LOCAL HISTORIC DISTRICT: Wilmore

PROPERTY ADDRESS: 301 West Kingston Avenue

SUMMARY OF REQUEST: Front porch addition

Charlotte Historic District Commission Case 2017-439
HISTORIC DISTRICT: WILMORE
ADDITION

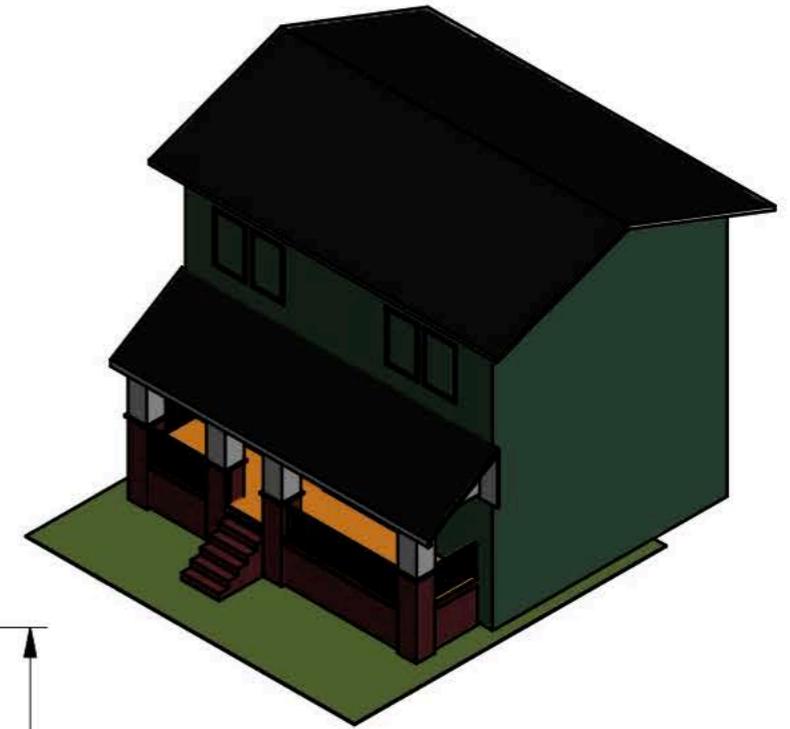
1. Porch Columns – Revised to squared posts to compliment the foursquare house design including dimensions. Porch piers are brick and posts are wood.
2. Precedents – Applicant has included design precedents for the porch design.
